Access Compliance Report

Public Rights-of-Way

(Curb Ramps)

Intersection ID: 1001734	Main Street: FLAT_RIVER_DR	Cross Street: OVERLAND_PARK_LN	Location:	N
ADA ID: DF6CBB5586F0	Ramp Type: Perp	Initial Pass/Fail: Fail	Overall Compliance: No	Severity Score: 37.5
Codes/Mitigation Info/Possible Solution		Field Measurements/Component Compliance

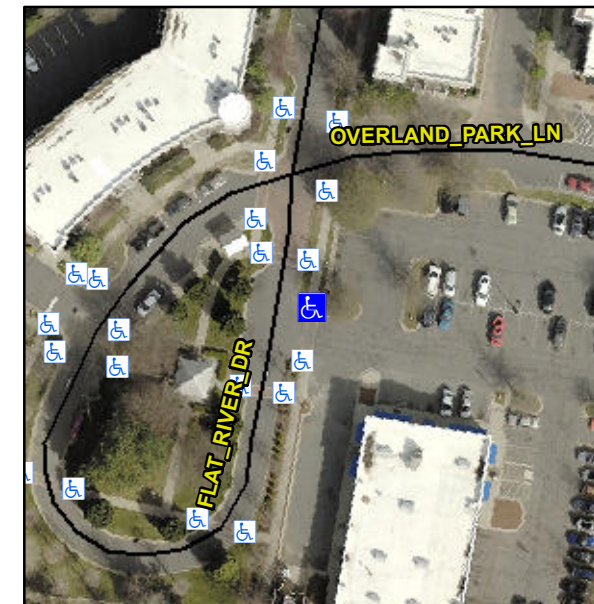
Compliance	Description	Data	Compliance	Description	Data
N/A	Ramp Length (in)	74.5	No	Ramp Slope (%)	13.3
Yes	Ramp Width (in)	48.5	No	Ramp XSlope (%)	5.7
N/A	Flare Type LT	N/A	N/A	Flare Type RT	N/A
N/A	Flare Slope LT (%)	N/A	N/A	Flare Slope RT (%)	N/A
N/A	Flare Traversable LT?	N/A	N/A	Flare Traversable RT?	N/A
N/A	Landing Length (in)	N/A	N/A	DWS Provided?	N/A
N/A	Landing Width (in)	N/A	N/A	DWS Contrast?	N/A
N/A	Landing Slope (%)	N/A	N/A	DWS Length (in)	N/A
N/A	Landing X Slope (%)	N/A	N/A	DWS Full Width?	N/A
N/A	Landing Curb? (Y/N)	N/A	N/A	DWS Offset (in)	N/A
N/A	Shared Landing?	N/A			
N/A	Gutter Ponding?	N/A	N/A	Gutter Slope (%)	N/A
N/A	Gutter Lip Ht (in)	N/A	N/A	Gutter X Slope (%)	N/A
N/A	Painted X Walk1?	Yes	N/A	Painted X Walk2?	N/A
	X Walk 1 Direction	To S		X Walk 2 Direction	N/A
N/A	X Walk 1 Width (in)	51.0	N/A	X Walk 2 Width (in)	N/A
	X Walk 1 Slope (%)	2.1		X Walk 2 Slope (%)	N/A
	X Walk 1 X Slope (%)	2.4		X Walk 2 X Slope (%)	N/A

N/A	Ramp inside XWalk1?	Yes	N/A	Ramp inside XWalk2?	N/A
	Road Slope (%)	N/A	N/A	Clear Space?	N/A
	Road X Slope (%)	N/A	N/A	Clear Space to XWalk (in)	N/A
N/A	Any Obstructions?	N/A	N/A	Storm Grate/Utility Hazard?	N/A
	Obstruction Type			Storm Grate/Utility Type	
		N/A			N/A
			Yes	Surface Condition? (G/P)	Good

Remove & Replace Entire Ramp.
